ITB 21-04-01
Emergency Back-Up Generator Purchase
Removal and Installation
Addendum 2
May 7, 2021

The following corrections, questions, and clarifications are provided concerning WSIPC ITB 21-04-01 Emergency Back-Up Generator Purchase, Removal and Installation. Paraphrasing of the relevant questions posed to the WSIPC RFP Bid Contracts Administrator have been included as appropriate.

MITSUBISHI ELECTRIC CORPORATION		TITLE	SHEETNo. E02
作成日付 DATE	JULY .1 .2008	SINGLE LINE DIAGRAM	BOARDNo.
作成・図章 DRAWN	S.Takubo K.H	DWG.No.	PAGENO.
設計・検査 APPROVED	T.Kawahara K.H	3DAA1050	003/006

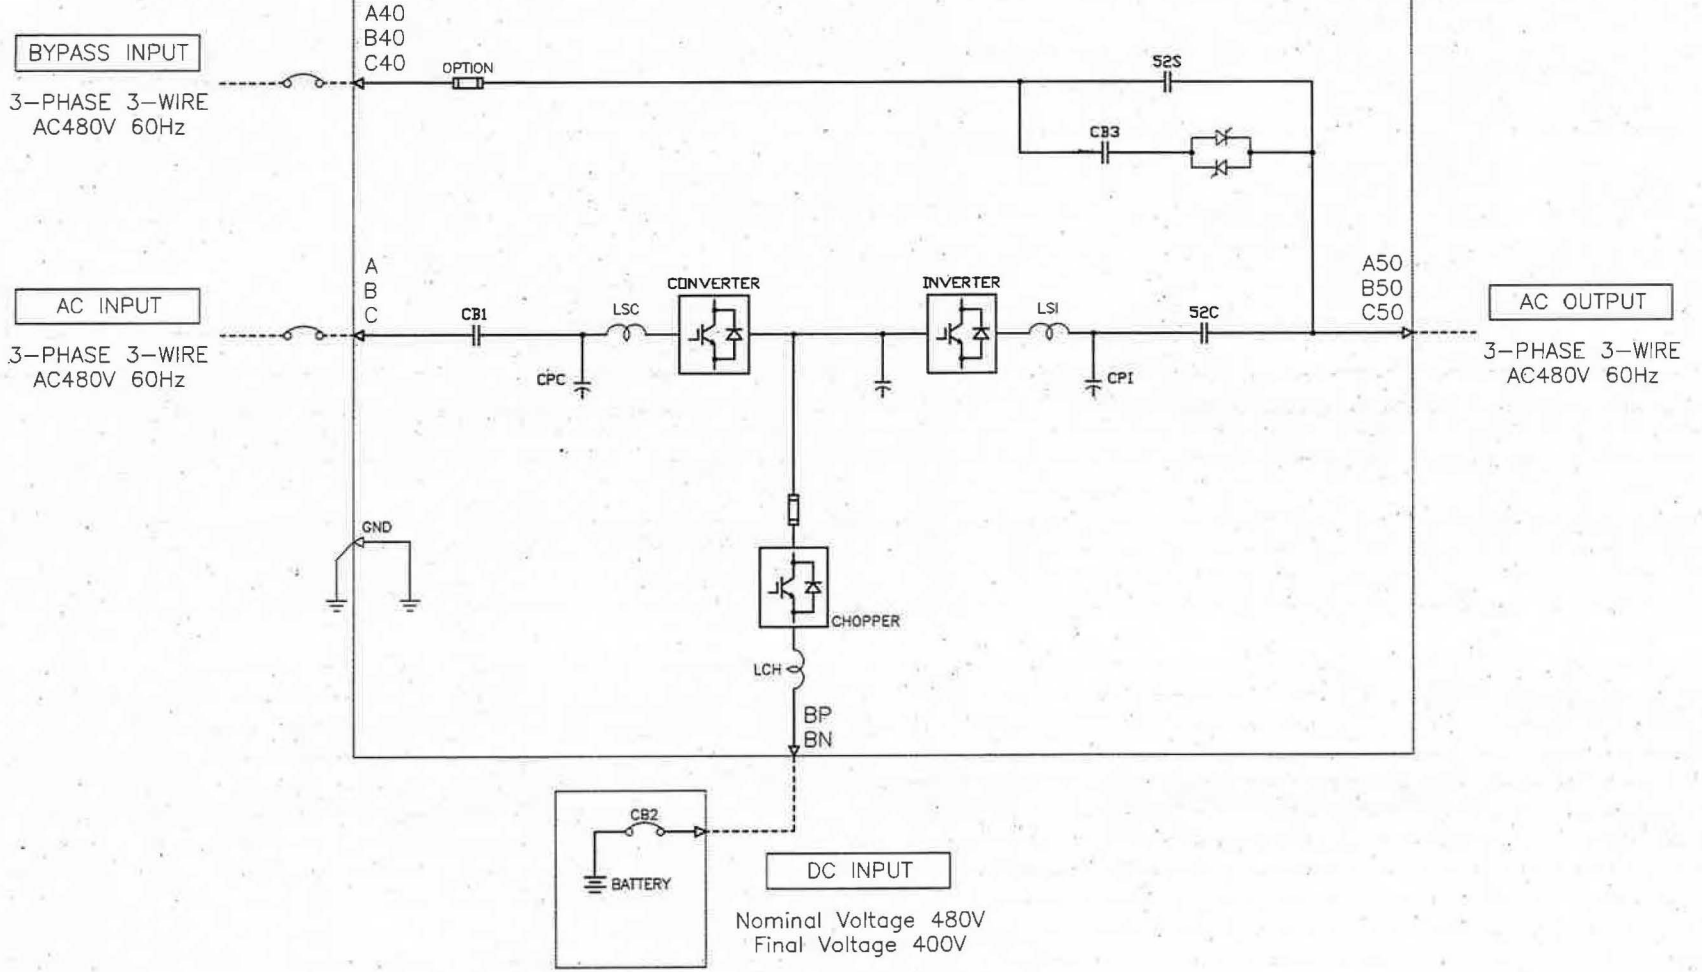
Q23 – Can we get access to the one (1) line drawing(s)

A23 – Yes, Mitsubishi 9900A Series UPS Schematic Diagram List (including Line 1 Drawings). Please see (pgs. 5-10).
